T10/07-391 revision 3

Date: January 15, 2008

Subject: SAS-2: Limiting SAS Target response to OPEN_REJECT (RETRY)

2 Proposed SAS-2 changes

Figure 1 — Port layer examples

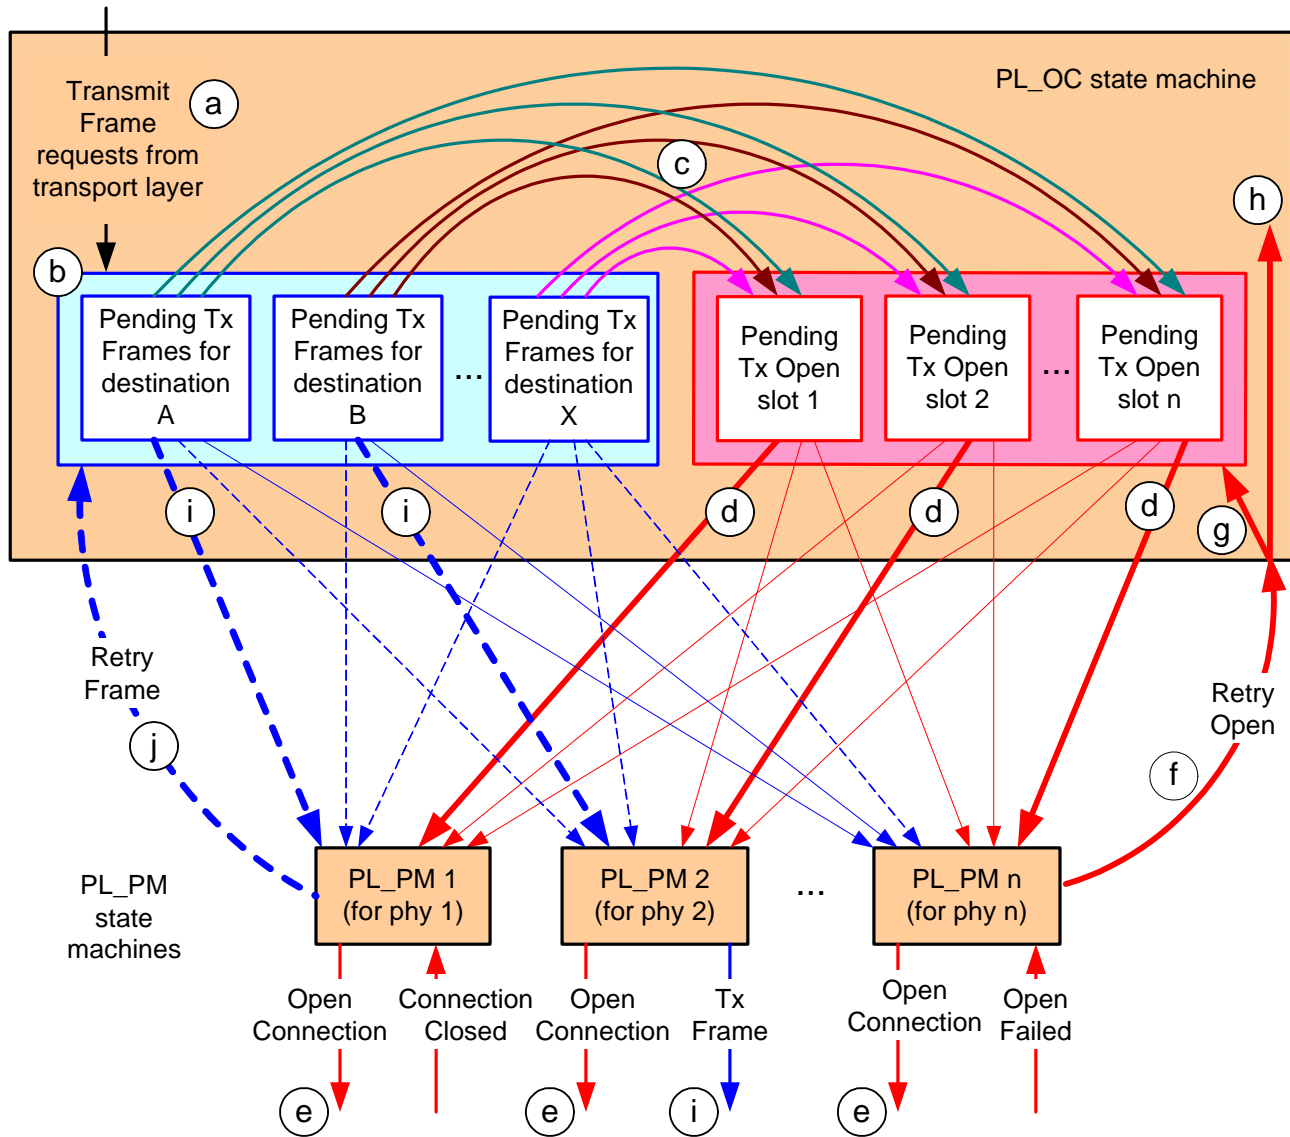
~~the PL_OC state machine converts a Retry Open message to a pending Tx Open message if there is a pending Tx Open slot available; if the PL_OC state machine converts a Retry Open message into a pending Tx Open message, then the pathway blocked count and arbitration wait time context from the Retry Open message are applied to the pending Tx Open message;~~

- g) after the Reject To Open Limit timer, if any, has expired, and if there is a pending Tx Open slot available, then the PL_OC state machine converts a Retry Open message to a pending Tx Open message with the pathway blocked count and arbitration wait time context from the Retry Open message applied to the pending Tx Open message;

- h) if the PL_OC state machine does not convert a Retry Open to a pending Tx Open frame, then the PL_OC discards the Retry Open message. The PL_OC state machine may create a new Tx Open message for the same pending Tx Frame at a later time. If the PL_OC state machine discards a Retry Open message, then the pathway blocked count and arbitration wait time context from the Retry Open message are also discarded;
